# RENESAS TECHNICAL UPDATE

Product Category	MPU/MCU		Document No.	TN-RH8-B0373A/E	Rev.	1.00
Title	Additional restrictions for the location of RH850 G3M branch instructions		Information Category	Technical Notification		
Applicable Product	RH850/C1H, C1M RH850/D1x RH850/F1M, F1H, F1H-100 RH850/P1M, P1M-E, P1x-C		Lot No.	Reference Document	See related documents below.	
			All

## 1. Precautions for use : Restrictions for the location of branch instructions.

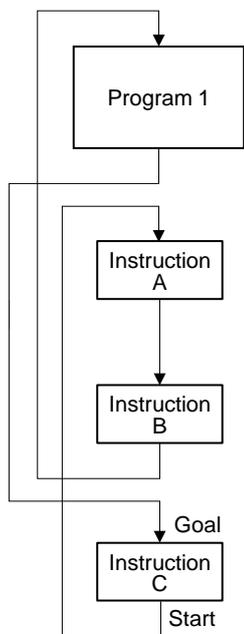
II. Dynamic conditions

When meeting **neither following conditions (a) nor (b)** while the period between Instruction C execution and the next Instruction C execution (Program 1 or Program 2 shown in below figures).

- (a) When executing Instruction E<sup>Note7</sup> even once.
- (b) When executing 4 or more Branch instructions D<sup>Note7</sup> that are Backward<sup>Note8</sup> and located on different addresses.

Sequence Example 1  
(Instruction A is not a branch instruction)

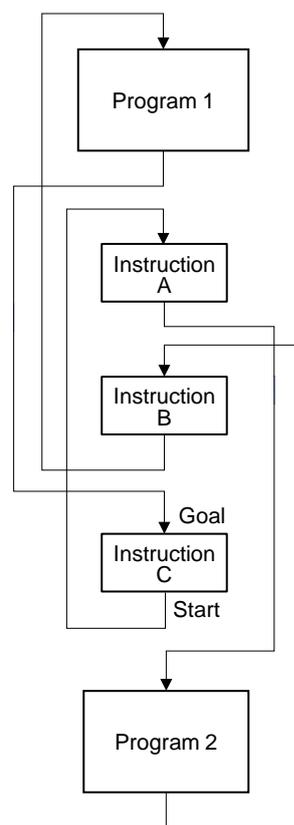
Sequence Example 2  
(Instruction A is a branch instruction)

<Judgment Flow>

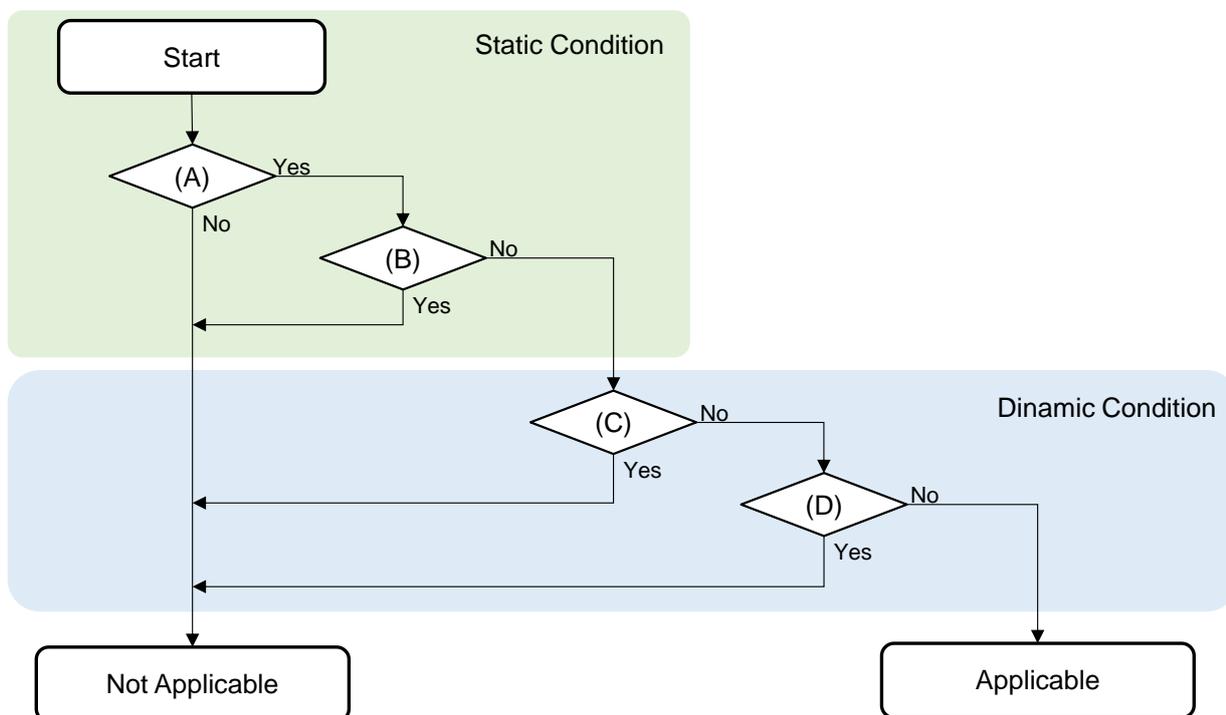
Please check whether static conditions are met, and please use the Check Tool of Static Condition that Renesas prepares to check the static conditions easier.

However, there is a possibility that the Check Tool of the Static Condition detects a point as applicable that is NOT applicable. So please confirm whether this detected point is a false detection or not.

If static conditions are met, please check whether either the dynamic conditions (a) or (b) are met. If either of these conditions is met, this phenomenon does not occur.

(A)	Is there a point that the Check Tool detects as Applicable?
(B)	Are all points that the Check Tool detects as Applicable, a false detection? (8. False detection for S-record files by Check Tool)
(C)	In points that the Check Tool detects, is the Instruction E <sup>Note9</sup> executed even once within the period between Instruction C execution and the next Instruction C execution?
(D)	In points that the Check Tool detects, are 4 or more Branch Instructions D <sup>Note9</sup> that are Backward <sup>Note10</sup> and are located on different addresses, executed within the period between Instruction C execution and the next Instruction C execution?

When the branch destination of Instruction C is backward, “jr” instruction is used instead of “br”,  
Alternatively, lowest 4-bit address of all Instruction A in applicable points must be different from 0xe by adjusting address of modules at linking time. In addition, there is a possibility that new applicable points occur by adjusting address of modules at linking time. Therefore, if new applicable points occur, please adjust the address again that these new points also become NOT applicable.
